Re: Revision to Floor Framing - Plan 7 - Sun Meadows
O'Connor Freeman Job Number: E030401

You recently contacted our office with a question regarding the framing of the floor of a Plan 7 at the Sun Meadows subdivision in Sacramento, California. We had previously addressed this issue as it related to Lot 13 with a letter dated September 24, 2004, but you requested that we broaden the letter to address all Plan 7s as they occur at the Sun Meadows subdivision. This letter is written to address this framing issue as it occurs on all Plan 7s.

Re: Shear Wall Penetrations; All Plans - Sun Meadows
O'Connor Freeman Job Number: E030401

Plan 7

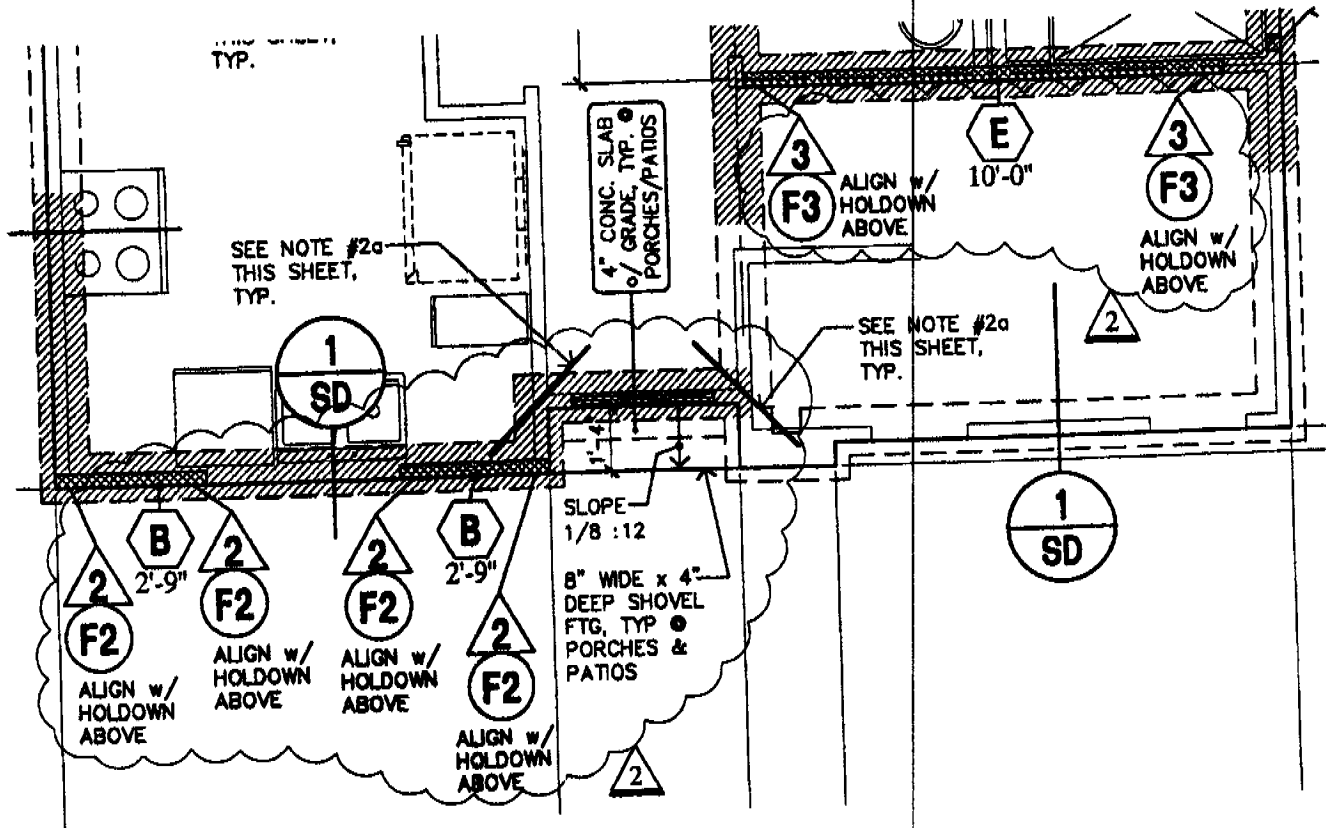
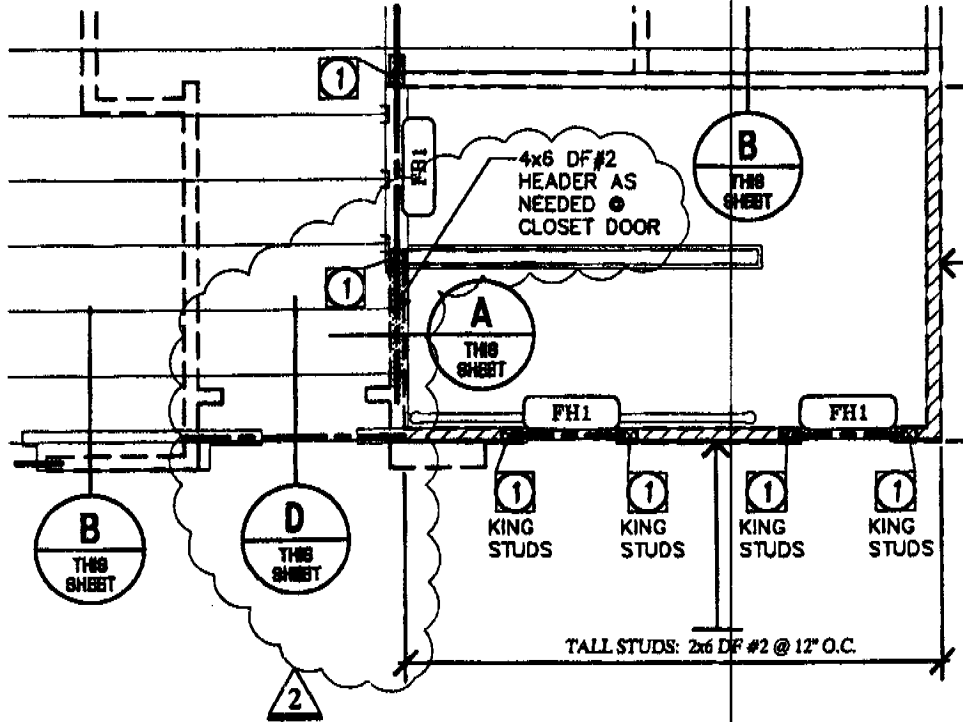
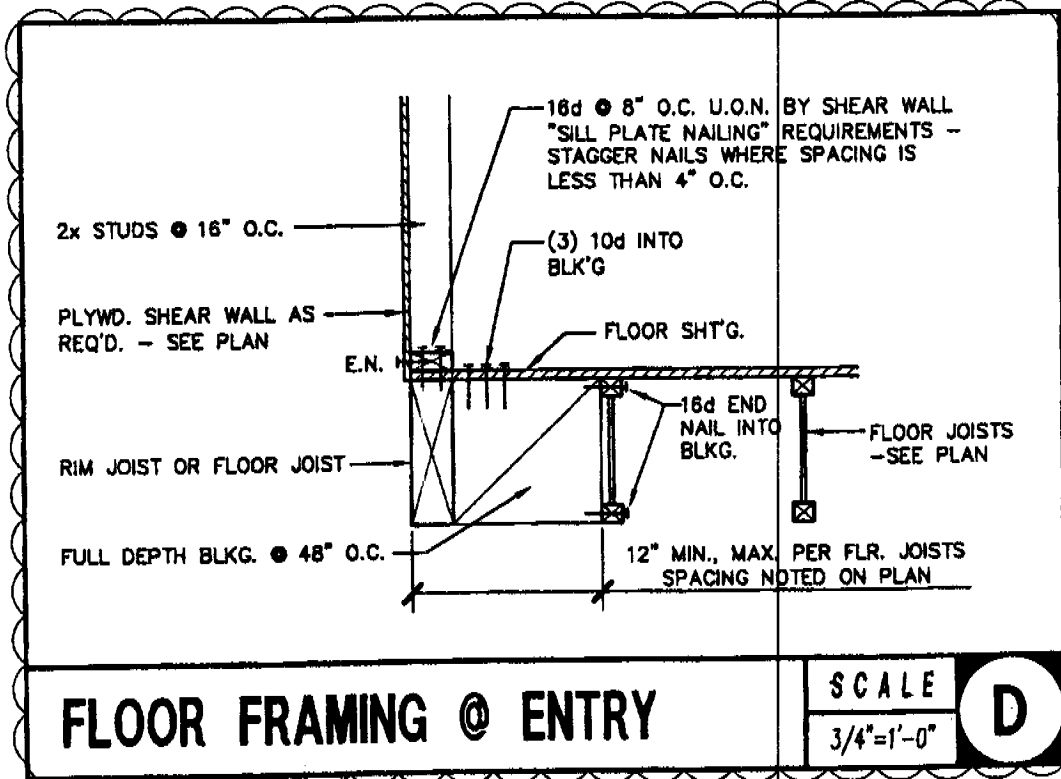
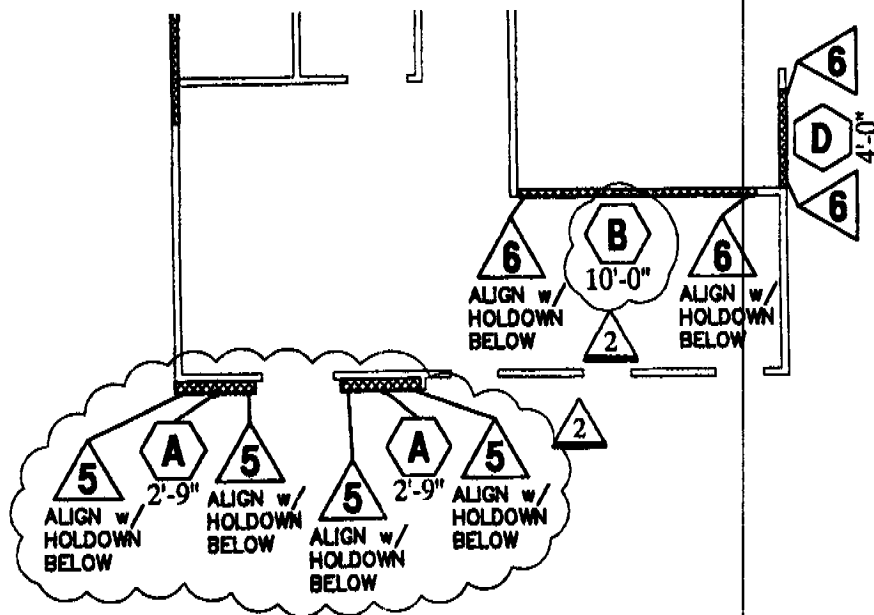
Initially, Christian Knippen requested that we clarify the framing requirements of the support of the second floor at the entry of the house. After further discussion, we found that it was desired to change the first floor layout, revise the shear wall layout, as well as more clearly detail the support requirements for the second floor at the entry.

We reviewed the photos he emailed to our office and found that the second floor wall at the entry was not supported AT ALL. There will be no instance where the second floor wall will not be supported by either an aligned floor joist, a bearing wall below or a beam (either dropped or flush). We have added a detail at that location to more clearly show the framing requirements for the second floor wall. We have also adjusted all the framing plans to show that the front door has been moved 8" closer to the front of the house and more clearly show the extent of the tall wall framing at the stairs. Please review the attached exhibits for further reference. We have also attached the appropriate calculation sheets for the changes to the shear wall layout.

SHEAR WALL PENETRATIONS

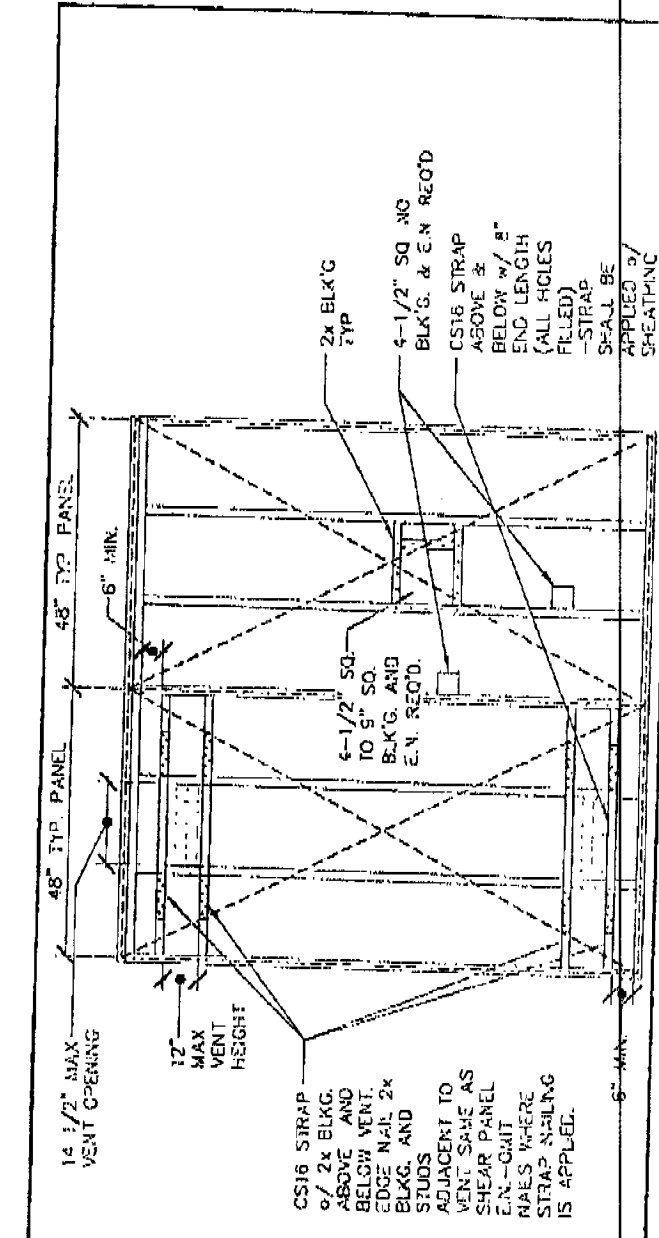
You contacted our office regarding a vent that was installed within shear wall on one of the plans within the Sun Meadows subdivision in Sacramento, California. The vent measured approximately 14 1/2-inches in width with a 12-inch maximum height and you wanted to know the engineering fix for cutting into the shear wall in order to install this vent. We have come across this situation several times and have developed a method of reinforcing small openings within a shear wall. Essentially, the framer will need to install blocking above and below the opening and strap this new blocking with a C'S16 strap. This strapping is not required for smaller openings. However, larger openings will need to be addressed separately on a case by case basis. See the attached detail for reference and review.

- NOTES:**
- 1) HOLES UP TO 4-1/2" SQ DO NOT REQUIRE BLK'G. & E.N.
 - 2) HOLES FROM 4-1/2" SQ. TO 9" SQ. REQUIRE BLK'G. & E.N.
 - 3) HOLES LARGER THAN 9" SQ. ARE NOT ALLOWED, UNLESS NOTED ON PLAN. ONLY ONE 9" SQUARE HOLE ALLOWED PER 4'-0" LENGTH OF SHEAR WALL. EXCEPTION: (2) VENTS ALIGNED IN THE SAME STUD BAY AS SHOWN ARE ALLOWED FOR EACH 8'-0" OF SHEAR WALL. IF SHEAR WALL IS LESS THAN 8'-0" LONG AND VENTS ARE DESIRED CONTACT ENGINEER.
 - 4) HOLE SIZE INCLUDES THE LENGTH OF THE OVERCUT.
 - 5) MAX. ACCUMULATED LENGTH OF OPENINGS SHALL NOT EXCEED 20 PERCENT OF THE SHEAR WALL LENGTH.
 - 6) RECOMMEND CIRCULAR BORED HOLES OR RADIUS CORNER CUTS (TO REDUCE STRESS CONCENTRATIONS). OVERCUTS NOT ALLOWED.
